**Paycor Stadium Southeast & Southwest VT Escalator Towers
Bid Package 2: Steel, Demo & Concrete
ITB#033-26
Addendum 3**

May 6, 2026

8 SECTION
S-201 3/4" = 1'-0"

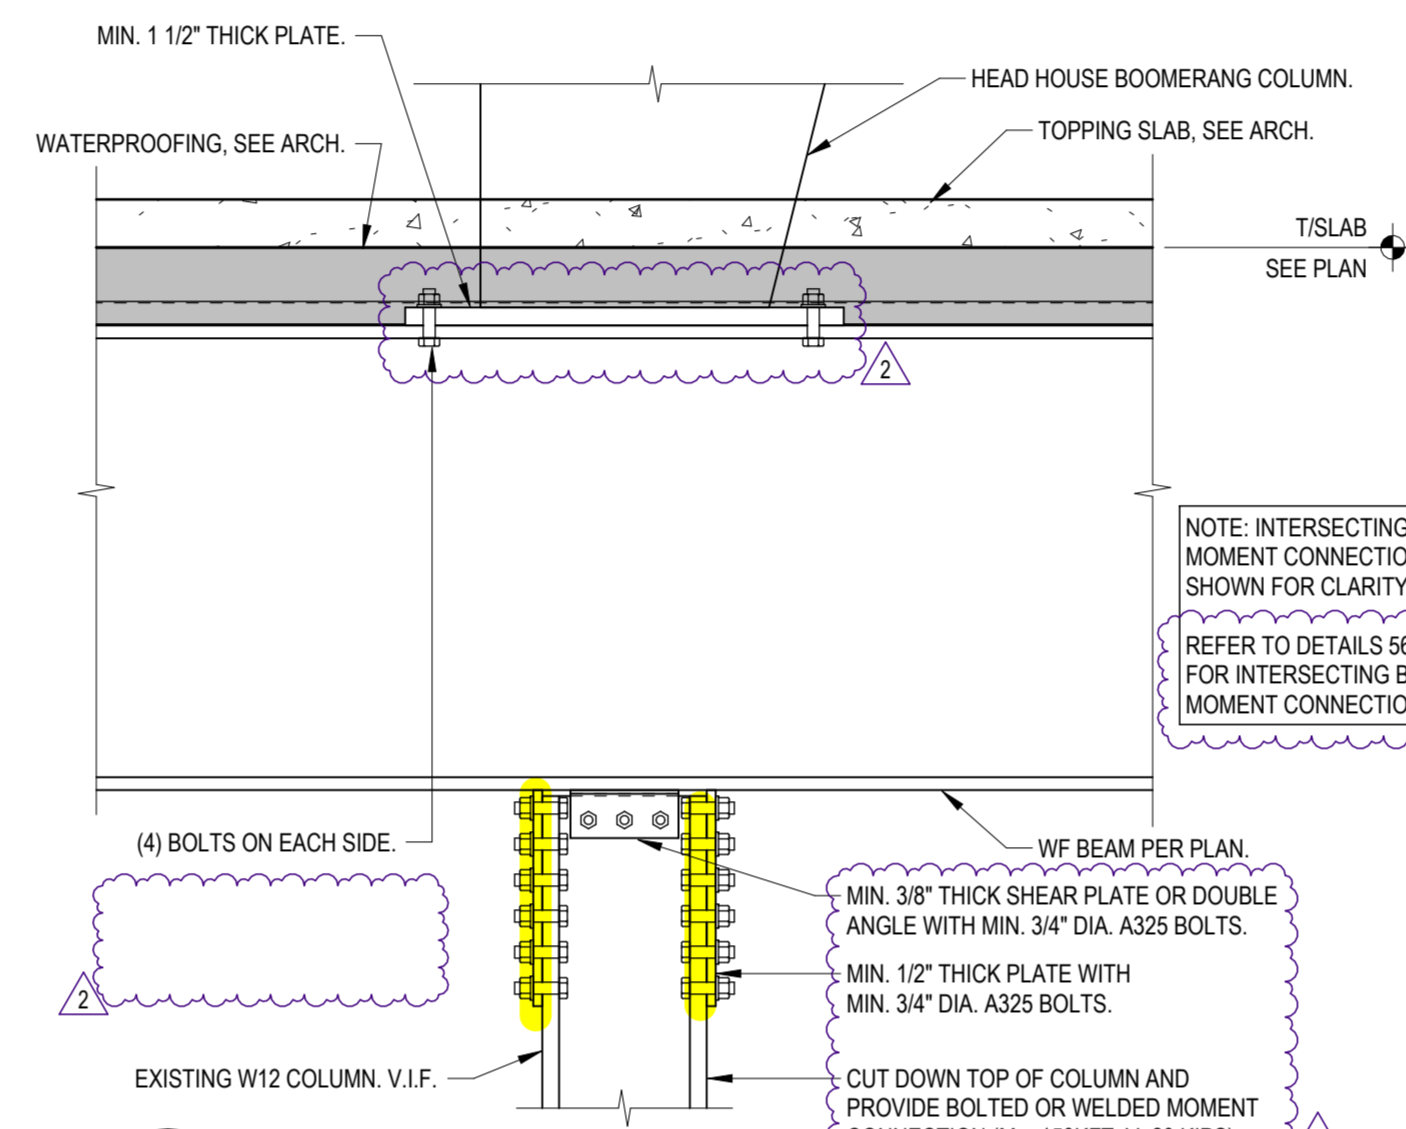
backside may have to be done during off season
SI contractor to provide small plates / multiple splices as necessary to facility install ass much as possible

46 SECTION
S-203 3/4" = 1'-0"

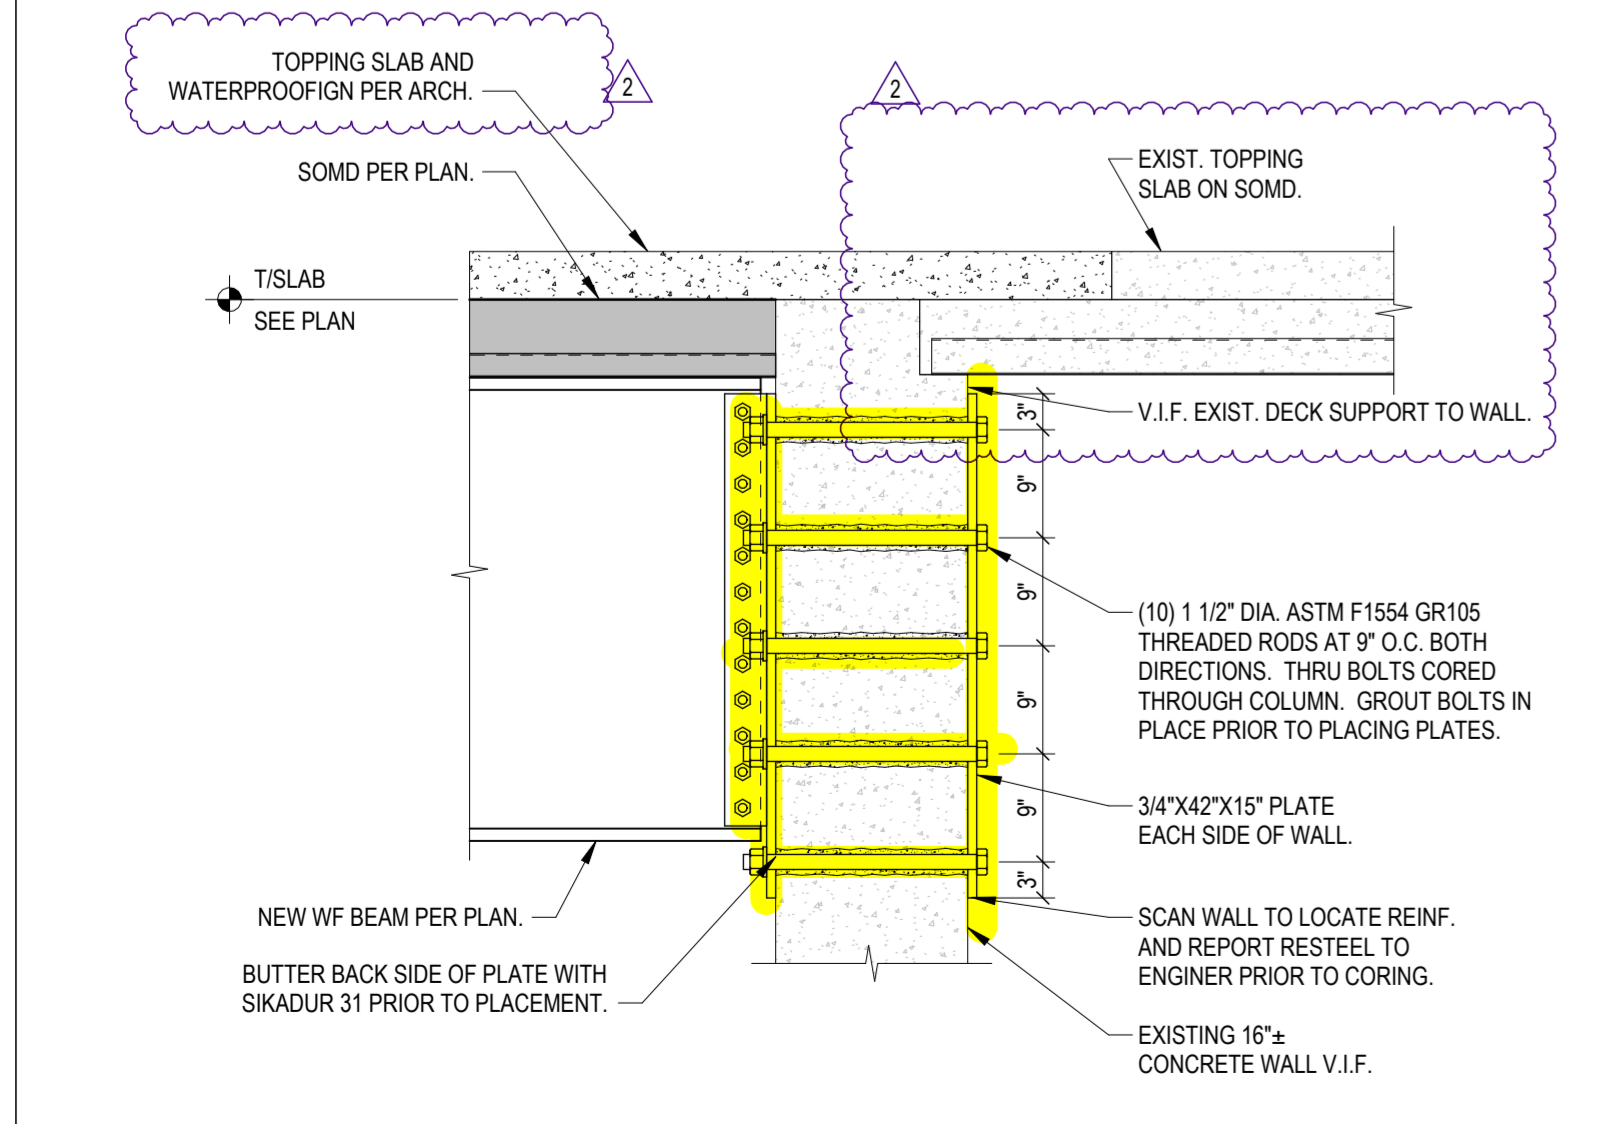
Connections / angles to be installed to fullest extent possible during on season
Demo contractor to take care not to damage during demo
Site contractor to provide temporary public protection consisting of rigid foam of any elements below 8'-0" from walking surface that may be stuck by the public

71 SECTION
S-204 3/4" = 1'-0"

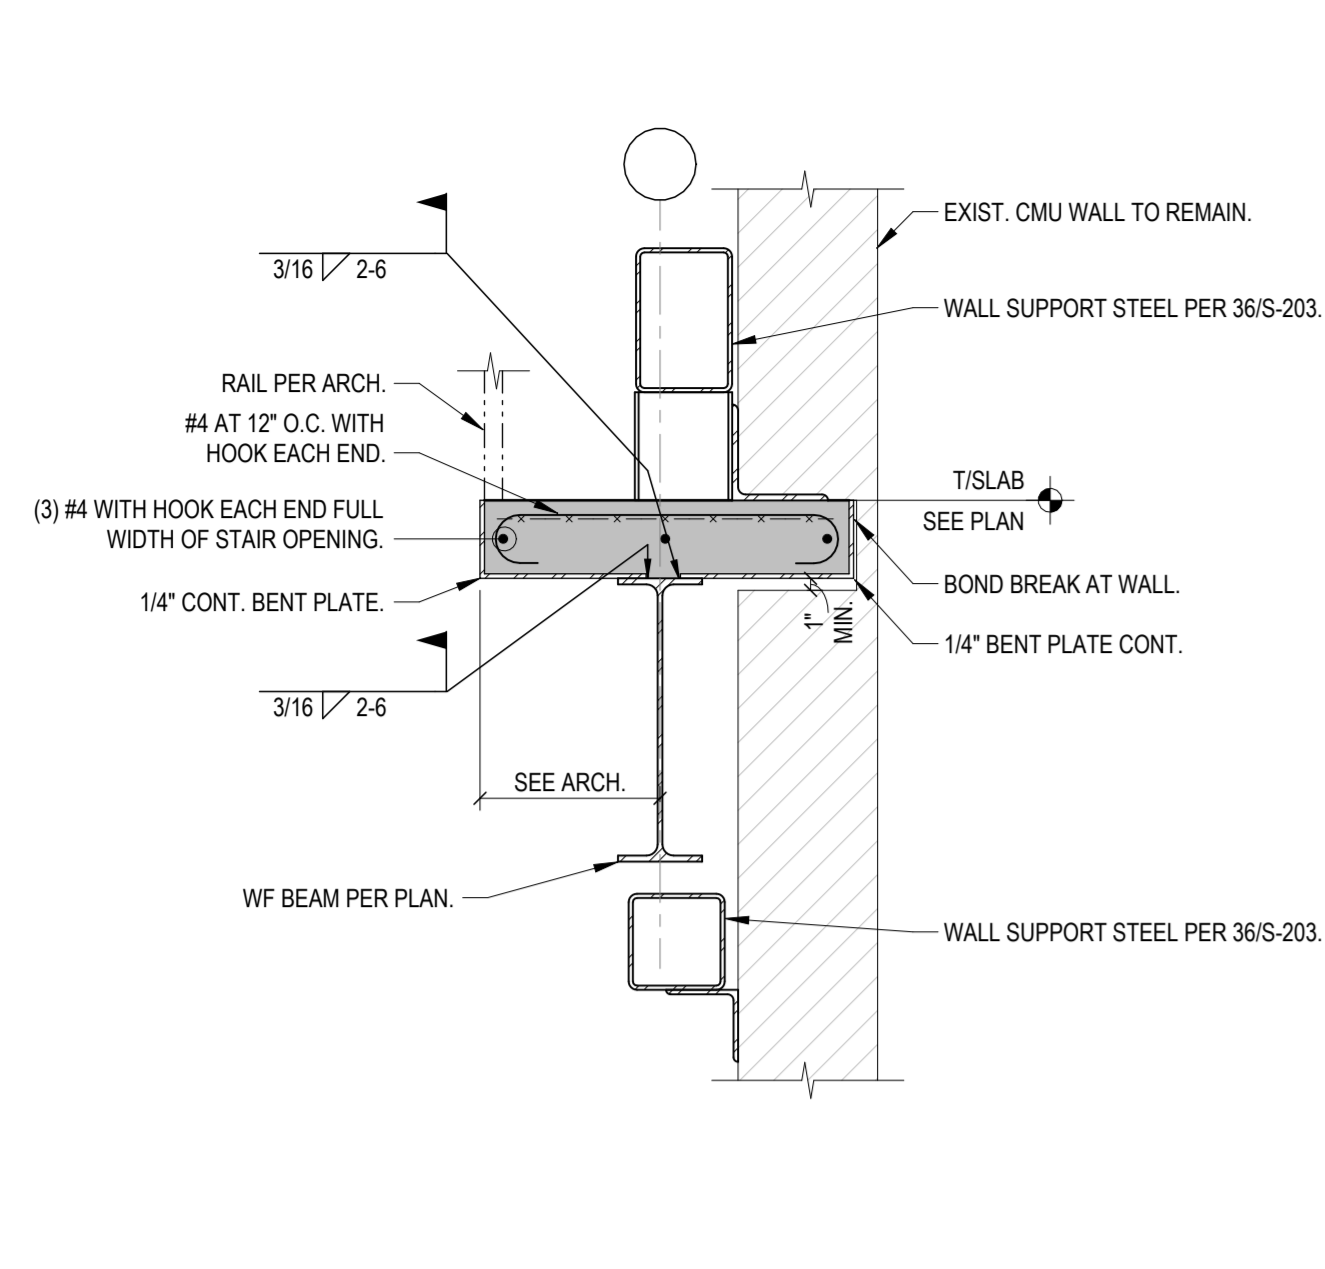
backside will have to be completed during onseason after interior wall demo is completed

SECTOR 4
1
S-301
FRAMING ELEVATION
1/8" = 1'-0"

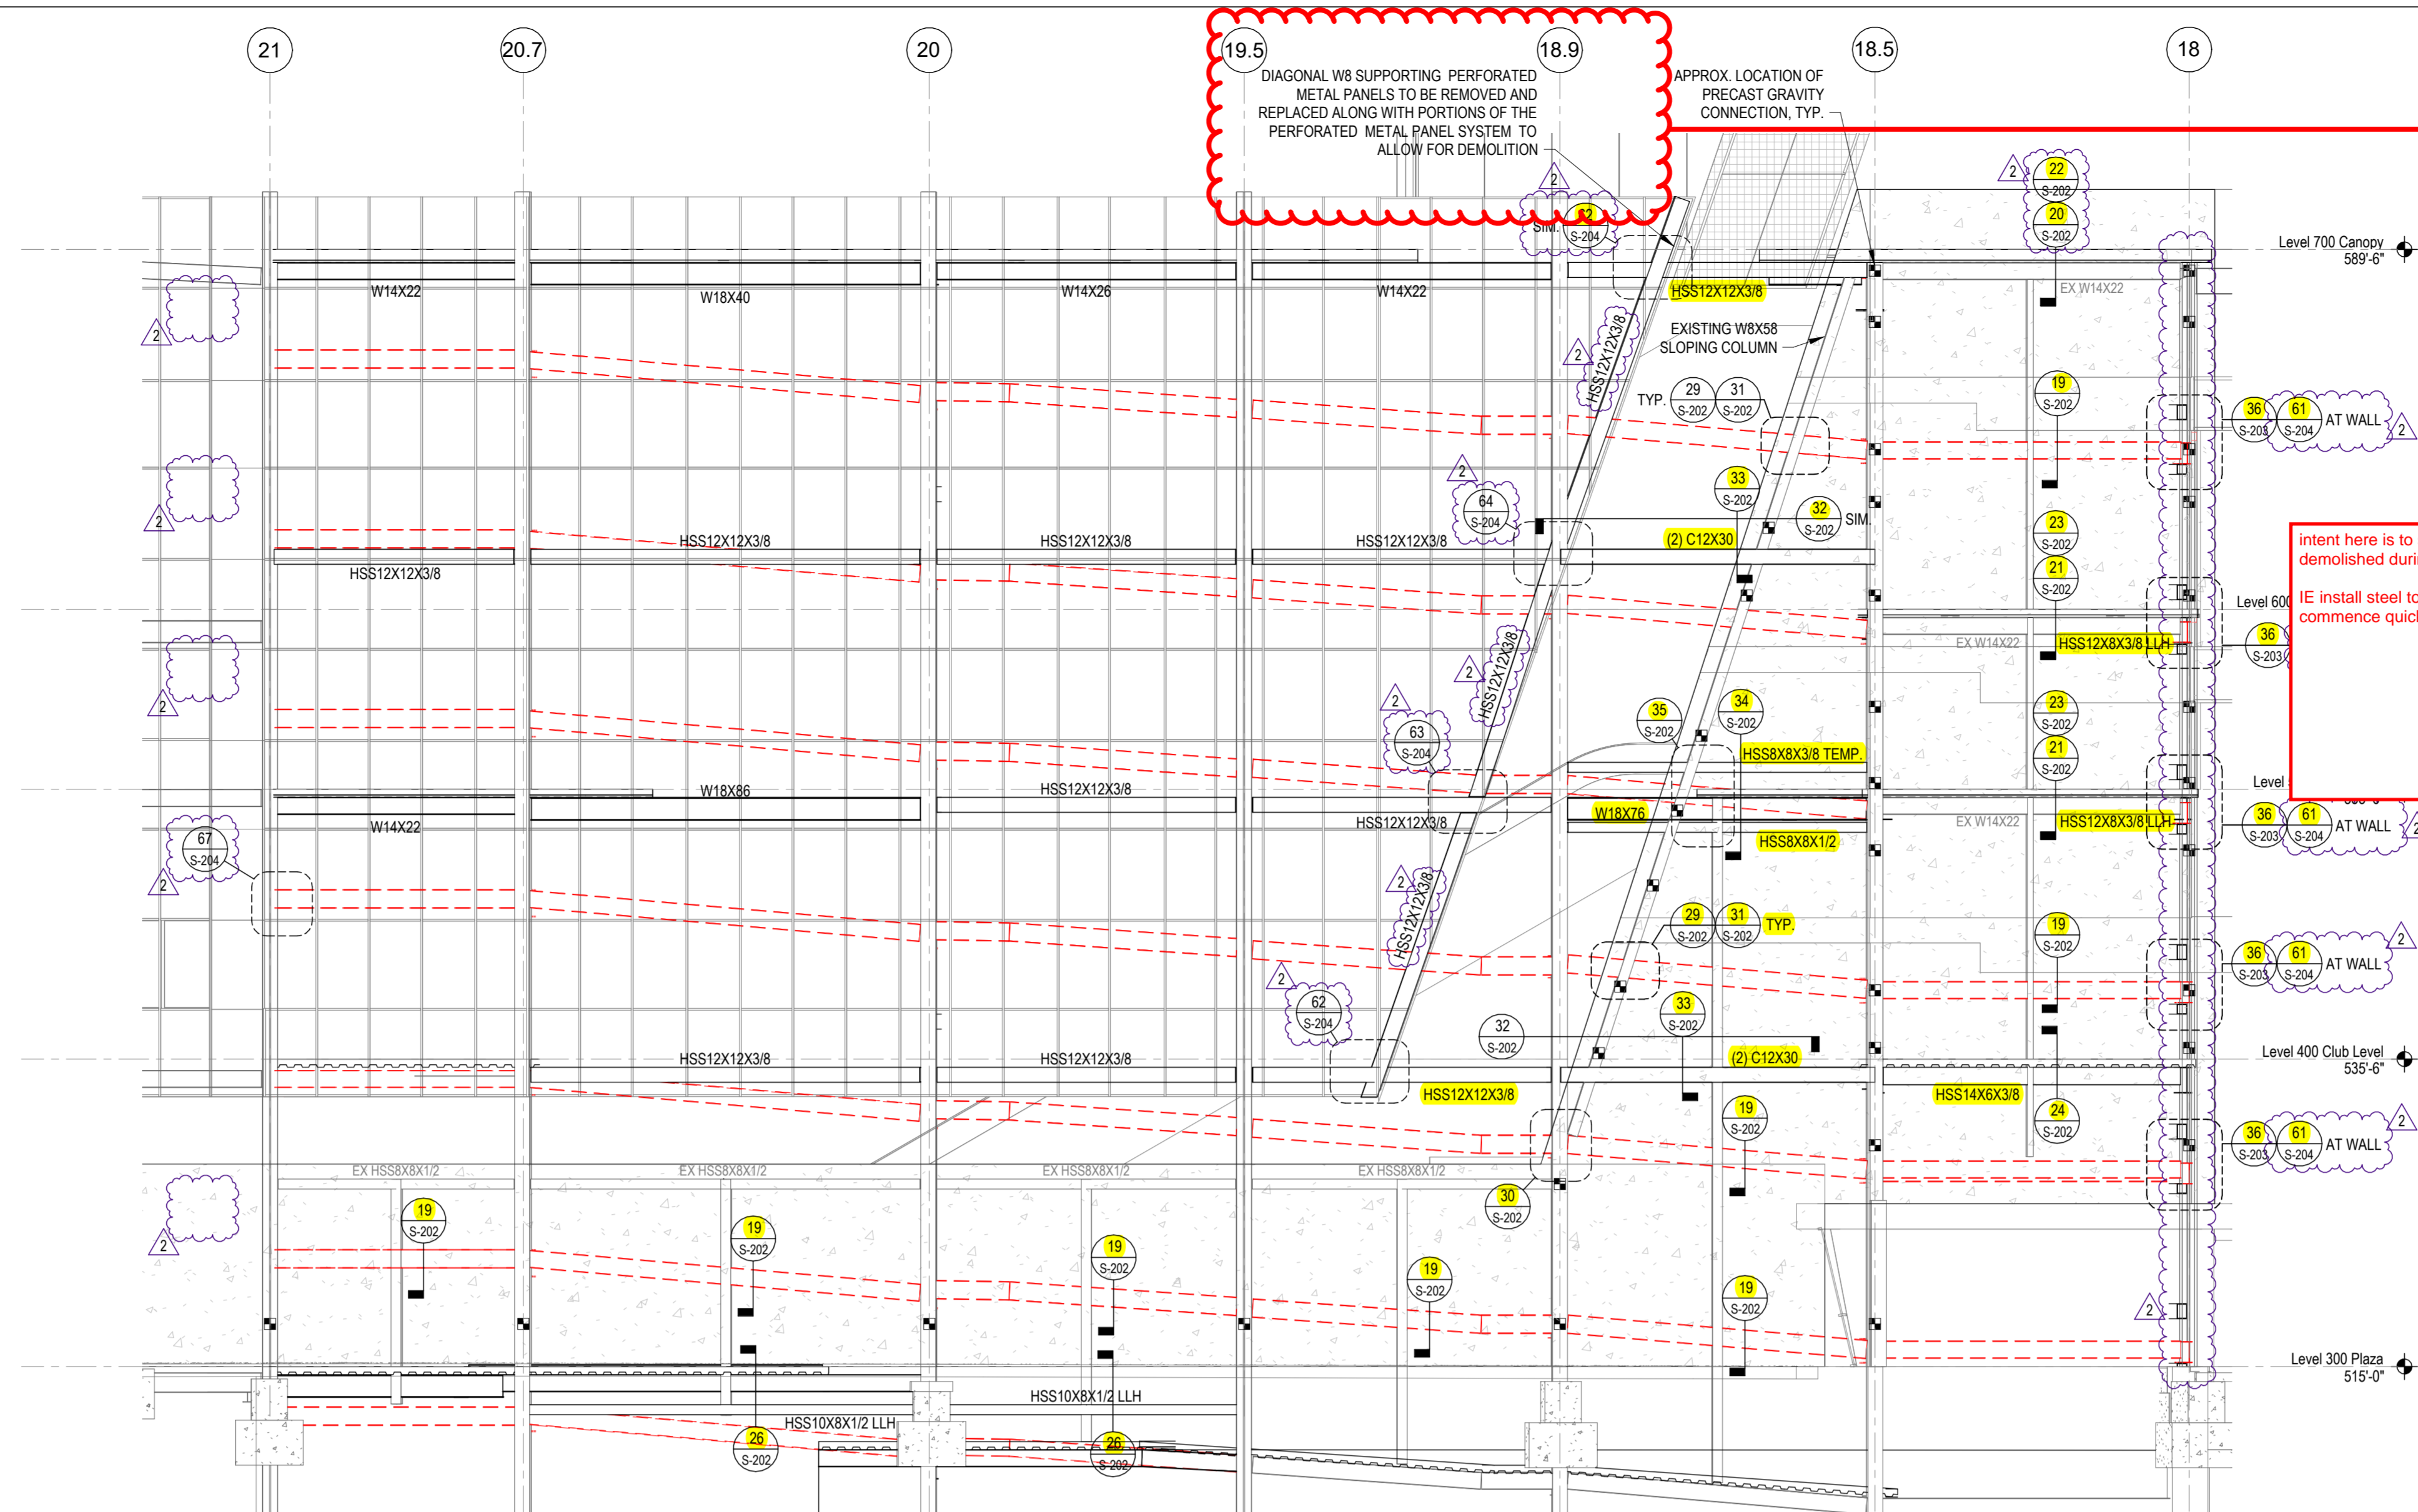
skin paneling can be removed On Season but associated steel cannot be removed / installed until off season

skin paneling can be removed during on-season, but associated steel cannot be removed / installed until off season
